6436 W. Hollywood Blvd
DOT Case No. CEN 16-44677

Subject: **TRANSPORTATION IMPACT ASSESSMENT FOR THE PROPOSED
MIXED-USE DEVELOPMENT PROJECT LOCATED AT 6436 WEST
HOLLYWOOD BOULEVARD**

The Department of Transportation (DOT) has reviewed the traffic impact analysis, dated January 2018 prepared by Gibson Transportation Consulting Inc., for the proposed mixed-use development located at 6430-6436 West Hollywood Boulevard and 1624-1648 Wilcox Avenue. In order to evaluate the effects of the project's traffic on the available transportation infrastructure, the significance of the project's traffic impacts is measured in terms of change to the volume-to-capacity (V/C) ratio between the "future no project" and the "future with project" scenarios. This change in the V/C ratio is compared to established threshold standards to assess the project-related traffic impacts. Based on DOT's traffic impact criteria¹, the traffic study included the detailed analysis of 22 intersections, including 19 signalized and three unsignalized and determined that the project-related traffic would significantly impact one of the study signalized intersections as summarized in **Attachment 1**. The results of the

FIGURE 1

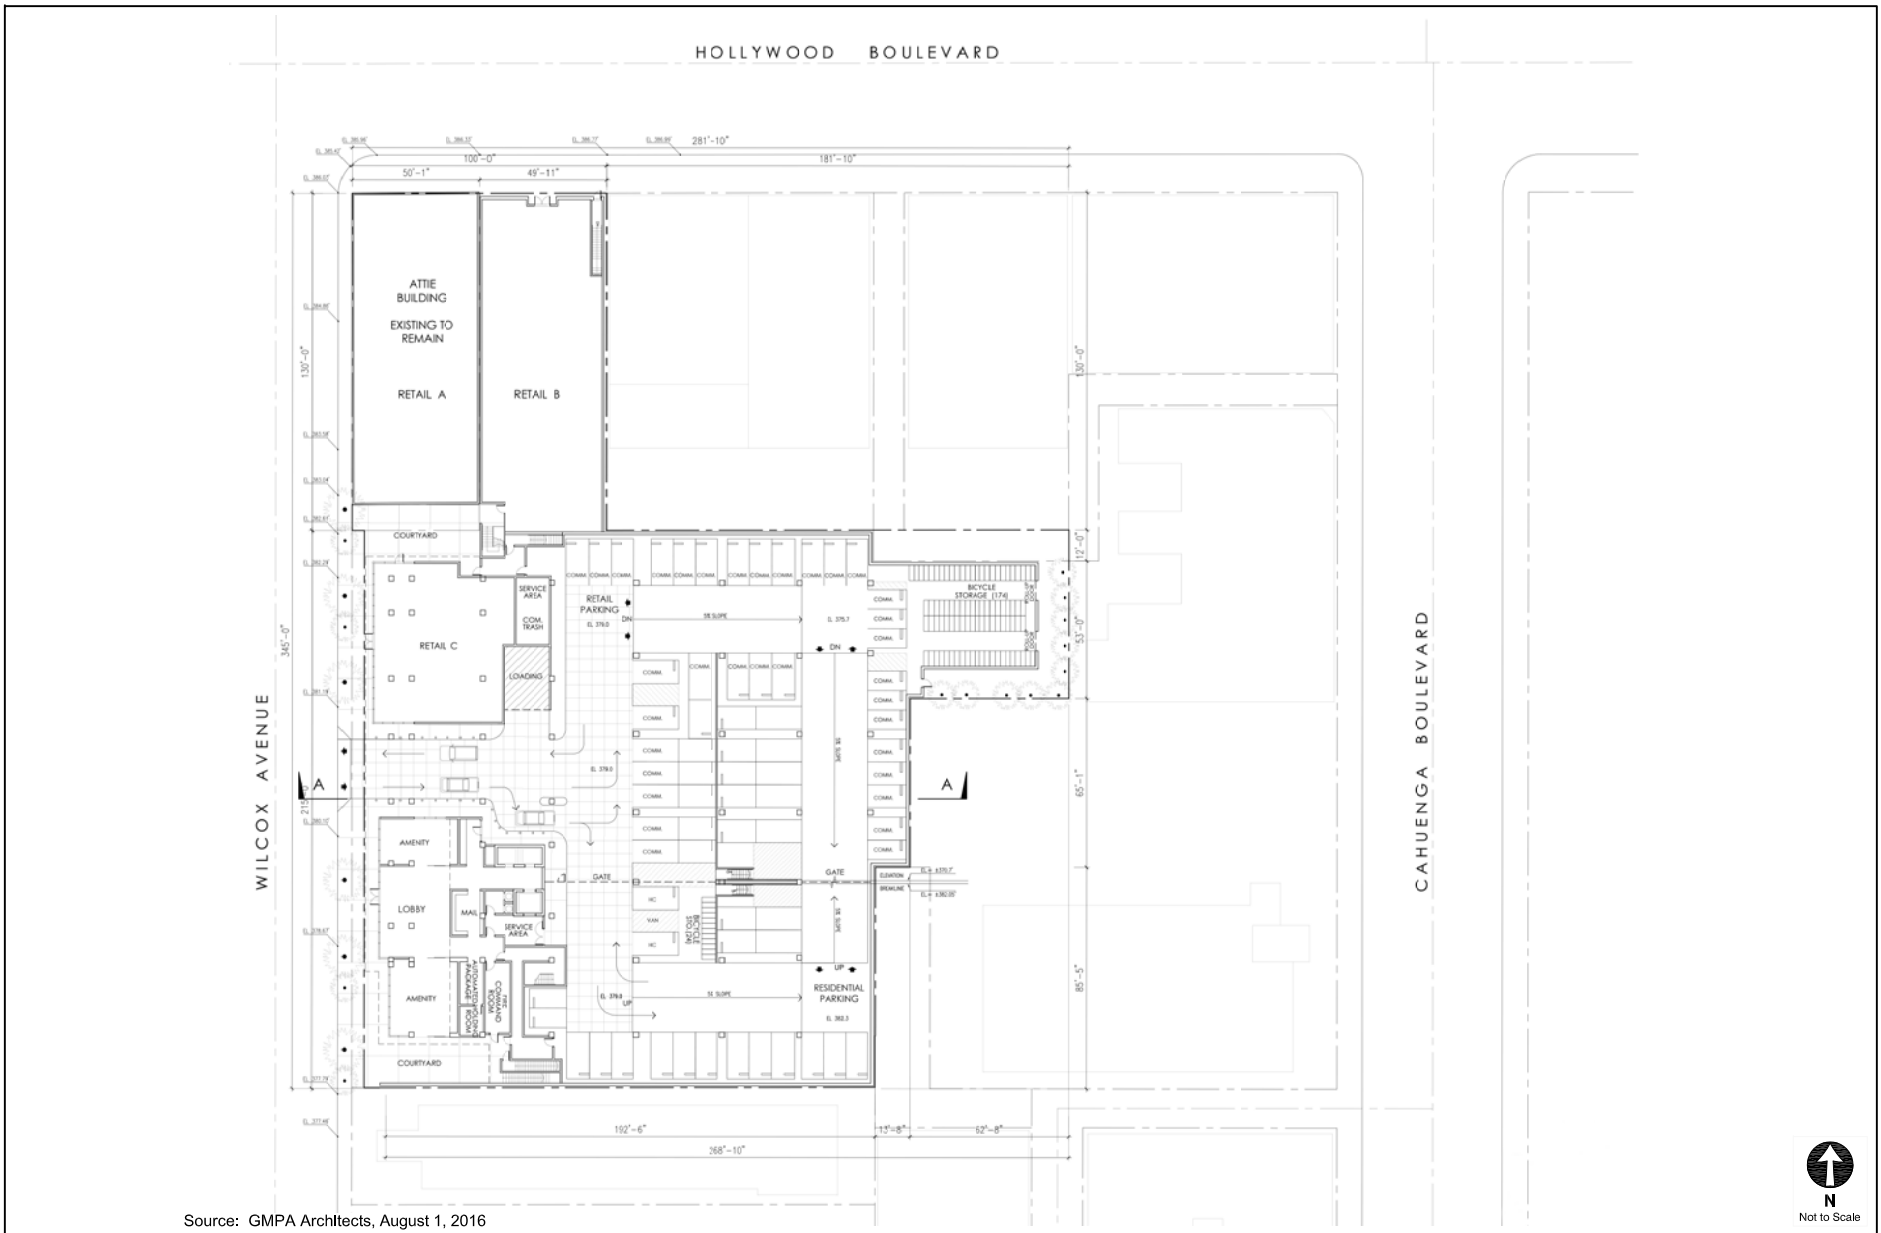
The proposed site plan illustrated in **Attachment 4** is acceptable to DOT; however, review of the study does not constitute approval of internal circulation schemes and driveway dimensions. Those require separate review and approval and should be coordinated with DOT's Citywide Planning Coordination Section (201 N. Figueroa Street, 5th Floor, Station 3, @ 213-482-7024). In order to minimize and prevent last minute building design changes, the applicant should contact DOT, prior to the commencement of building or parking layout design efforts, for driveway width and internal circulation requirements. Any changes to the project's site access, circulation scheme, or loading/unloading area after issuance of this report would require separate review and approval and should be coordinated as well.
